**NESC Review of the 8-Foot High Temperature Tunnel (HTT)  
Oxygen Storage Pressure Vessel Inspection Requirements**

**March 16, 2006**

**Appendix B. LOX Run Tank Sketch**

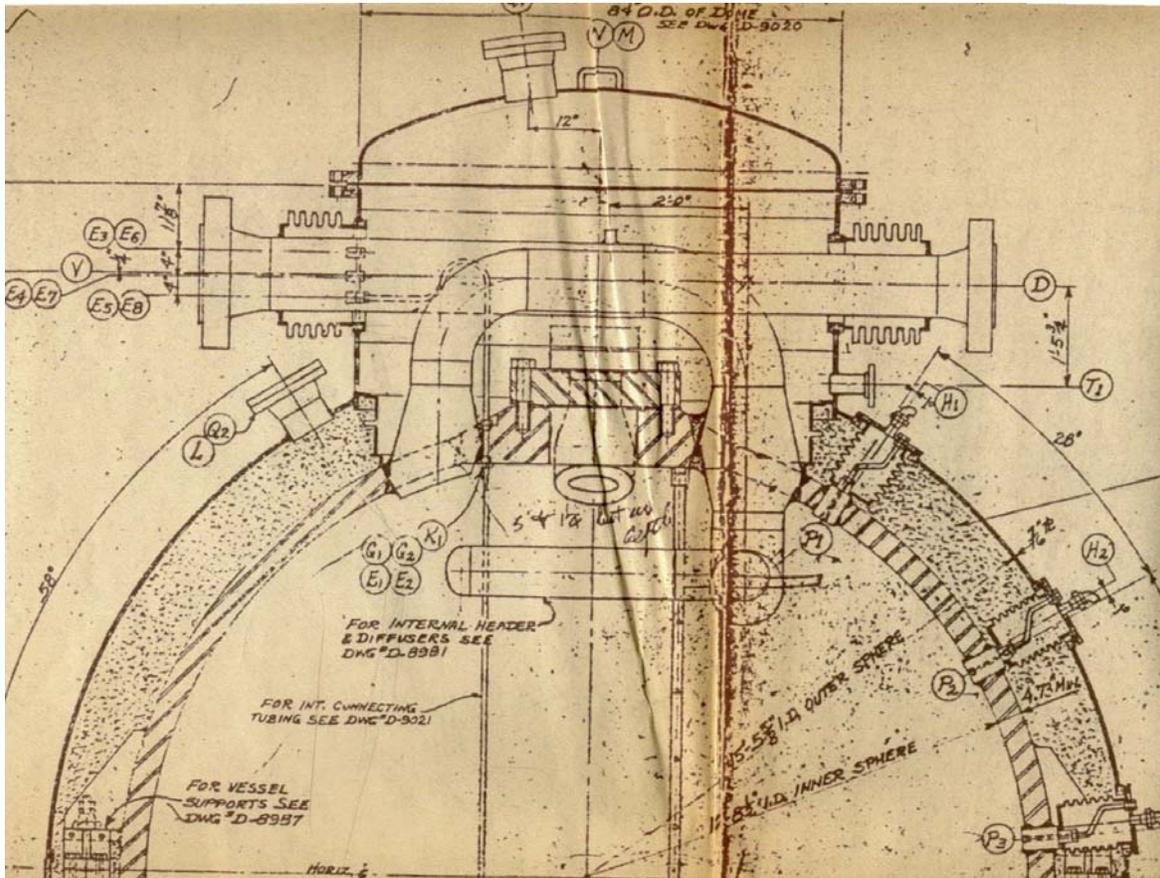
#### **LOX Run Tank (Refer to the sketch in Appendix B)**

- The tank was determined to be LBB by analysis.
- Monitoring of the vacuum level between the inner pressure shell and the external shell would identify the presence of through-cracks in the pressure shell and allow the facility to stop operations before catastrophic failure would occur.

**LOX Run Tank Model**

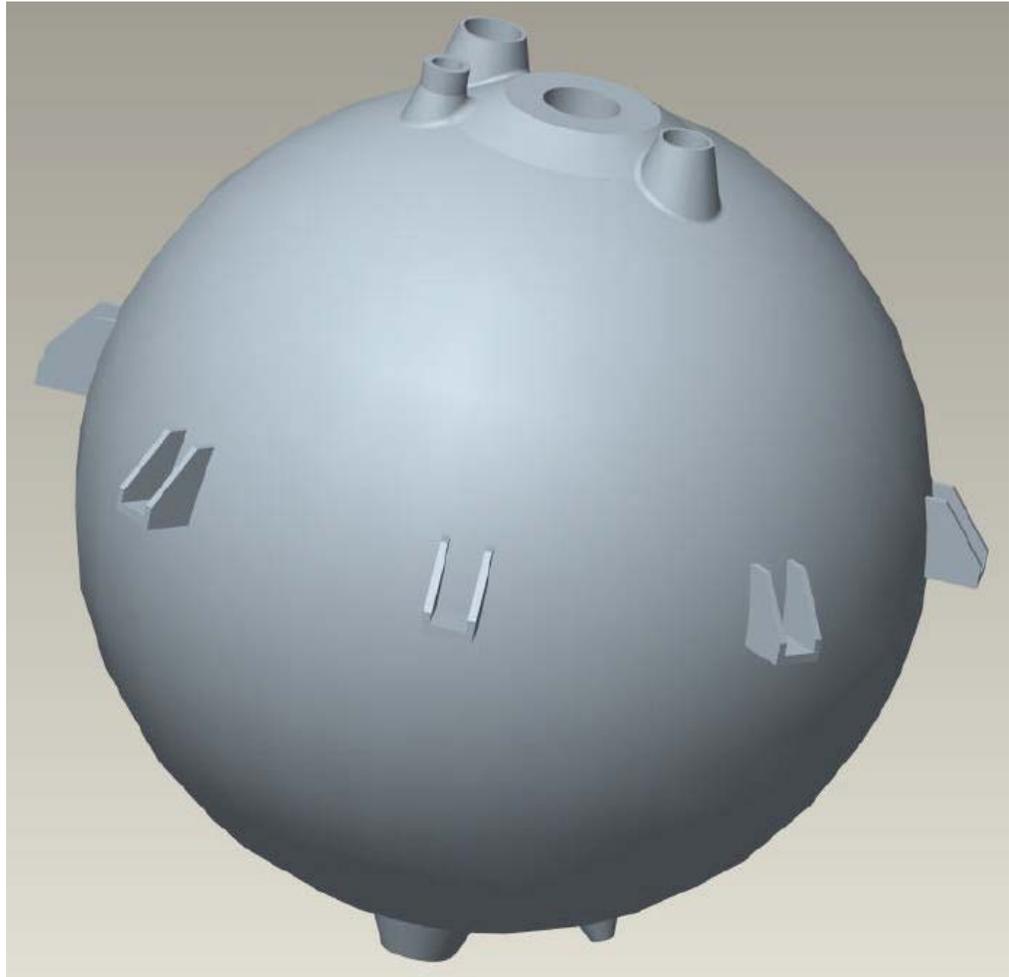
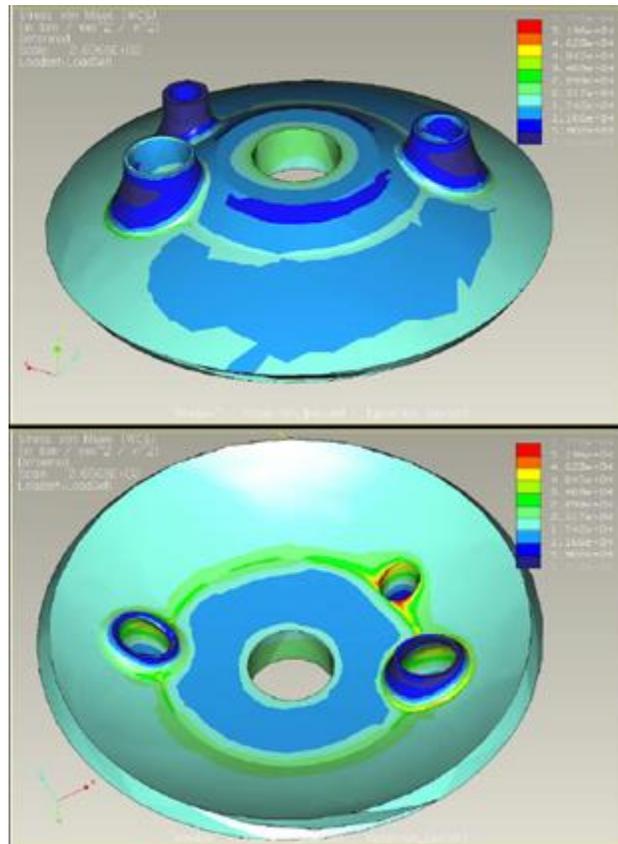
- Critical crack size is predicted to be less than the tank wall thickness.
- Fracture mechanics analyses did not account for weld material properties or residual stresses.
- The structural finite element models do not capture changes in thickness, geometry, loading, and material properties.

O-4. Atmospheric pressure load modeling in the revised analysis needs to be updated; the overall effect is expected to be very minor (order of 14/2250 psi).

- The atmospheric pressure acts on the external vacuum jacket shell and transfers to the LOX Run Tank pressure shell as point loads through standoffs, not as a uniform load on the pressure shell.
